SAFETY RECALL
NORTH AMERICA
Headlamp Aim Plugs

Reference: 23C / NHTSA 25V-174

Remedy available for
2024-2025 (KM) Wagoneer S

Figure 1 – Hole and Plug Locations

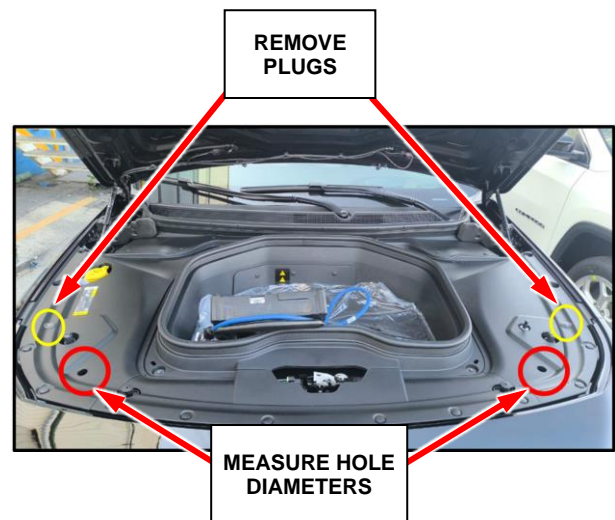
The headlamp aiming adjustment mechanisms on about 4,540 of the above vehicles may not have proper accessibility. **If headlamp aim is improperly adjusted it may reduce forward visibility for the driver and create glare for oncoming vehicle drivers, which may cause a vehicle crash without prior warning.**

The condition above fails to conform to the requirements of FMVSS No. 108 S10.18.1 which requires that each headlamp "must be installed [...] with a mounting and aiming mechanism [...] accessible for those purposes without removal of any vehicle parts, except for protective covers removable without the use of tools." Additionally, FMVSS No. 108 S10.18.4 requires that "A visually/optically aimable headlamp that has a lower beam must not have a horizontal adjustment mechanism..." Suspect vehicles do not allow access to vertical headlamp aim adjustment without the use of tools, and do allow access for horizontal headlamp aim adjustment.

1. Open the hood.
2. Inspect both cowl side panel covers for plugs in the vertical alignment holes. Remove and discard if present (Figures 1 and 2).
3. Measure the size of the horizontal alignment holes in both cowl side panels (Figure 1). It is possible for only one panel to require service.
 - Hole is 10mm in size, no further action needed.
 - Hole is 20mm in size, install rubber plug(s) (see parts section of this recall) (Figures 1 and 3).
